Subject: AP1000 COL Response to Request for Additional Information (TR #54)

Response to Request for Additional Information on Technical Report No. 54

RAI Response Number: RAI-TR54-08
Revision: 1

Figure TR54-8.1 LSDYNA Model of Pool Liner and Rack Pedestal Bearing

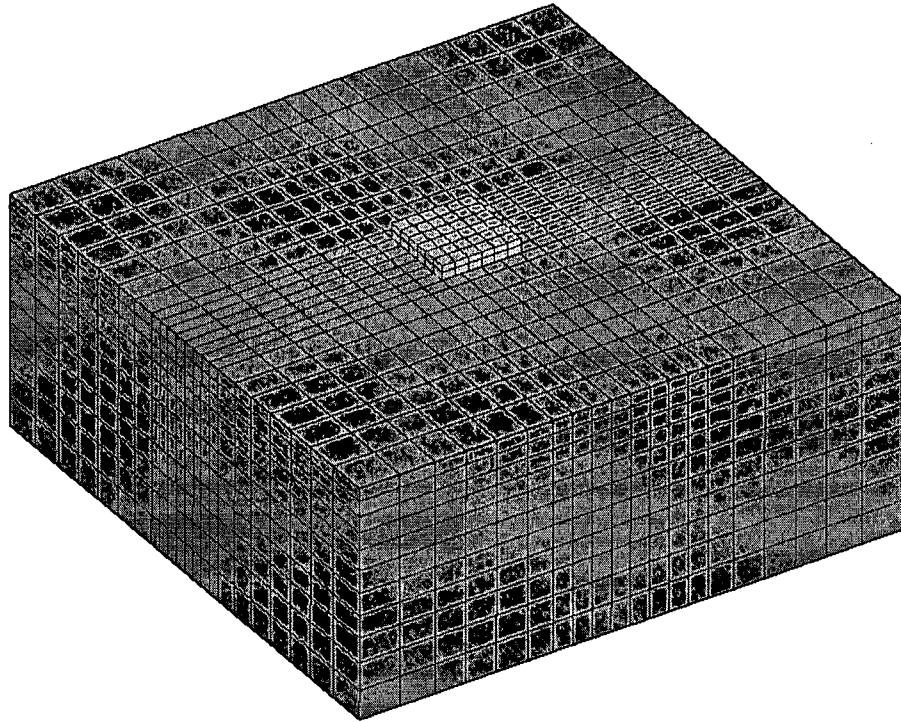
For the drop case in which the impact occurs directly above a rack pedestal, Section 2.8.5 provides the concrete strength of the pool floor and the thickness of the stainless steel liner, but does not provide the thickness of the pool floor. There is a possibility that the impact could also cause damage to the concrete floor, and pose a more severe consequence than yield of the liner. The maximum Von Mises stress in the spent fuel pool liner is reported as 23.4 ksi, which is much larger than the concrete strength of 4 ksi; the concrete may crush and crack locally at this level of stress. Therefore, provide additional details on the modeling of the concrete floor (including a figure of the concrete model, element type, boundary conditions, material properties, etc.) and the analysis results for the concrete floor (in addition to Figure 2-11).

The spent fuel pool concrete floor is modeled only in the vicinity of the impacted rack pedestal with an assumed thickness of two feet and compressive strength of 4,000 psi. The pool liner and rack pedestal bearing pad are also modeled as shown in Figure TR54-8.1. The periphery surface nodes of the SFP pool liner and the underlying concrete slab in the LSDYNA model are restrained from moving in the vertical direction and in the horizontal direction normal to the periphery surface to simulate the confining effect of the surrounding structure.

Figure TR54-8.2 LSDYNA Fuel Assembly Deep Drop Scenario 2

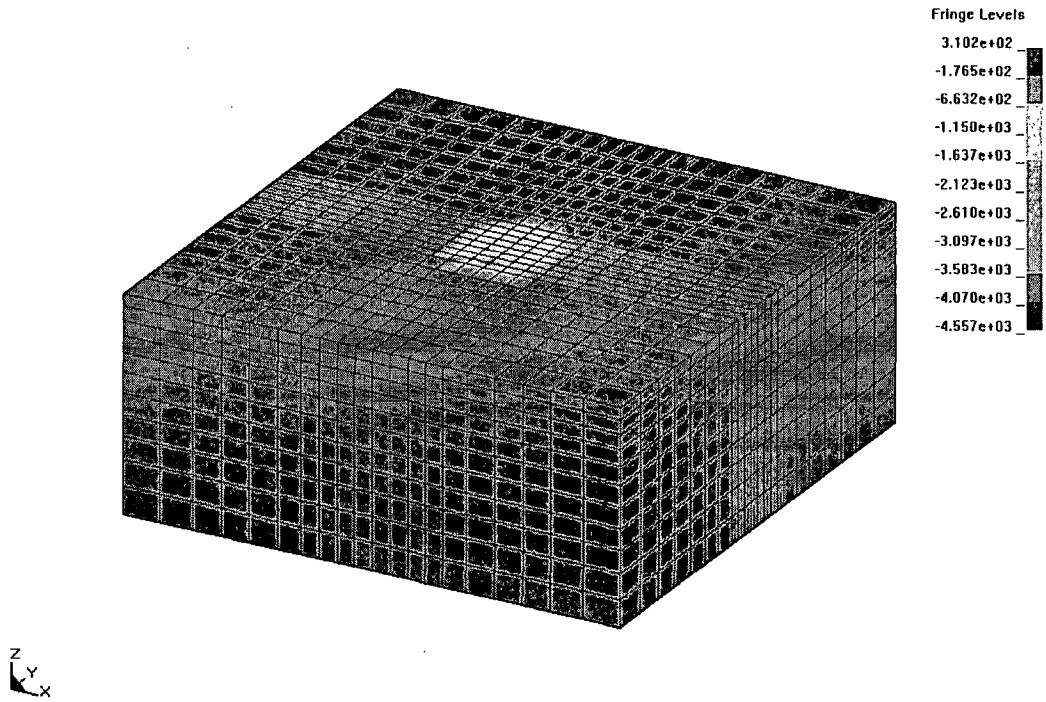
October 8-12, 2007 Audit "The staff still needs confirmation that the concrete compressive strength in NUREG/CR-6608 is 4,000 psi.

The maximum compressive stress in the concrete floor, resulting from the fuel assembly deep drop event in which the impact occurs directly above a rack pedestal, is predicted to be 4,557 psi as shown in the Figure TR54-8.2. This maximum compressive stress slightly exceeds the assumed concrete compressive strength and is limited to the top surface of the concrete near the bearing pad edge. The very limited local damage to the concrete floor surface is acceptable since the acceptance criterion for the fuel deep drop accident is no gross failure of the SFP floor leading to an uncontrolled loss of SFP water.

The concrete pad that is modeled in NUREG/CR-6608 has a compressive strength of 4,200 psi, which is slightly greater than the compressive strength of the AP1000 SFP slab (4,000 psi). In order to account for the difference in strength, the input parameters specified in Appendix C of NUREG/CR-6608, for use with LS-DYNA Material Model 16, have been modified in accordance with Holtec Position Paper DS-240 (see Attachment 1 to TR54-8, Reference 3) for a compressive strength of 4,000 psi.
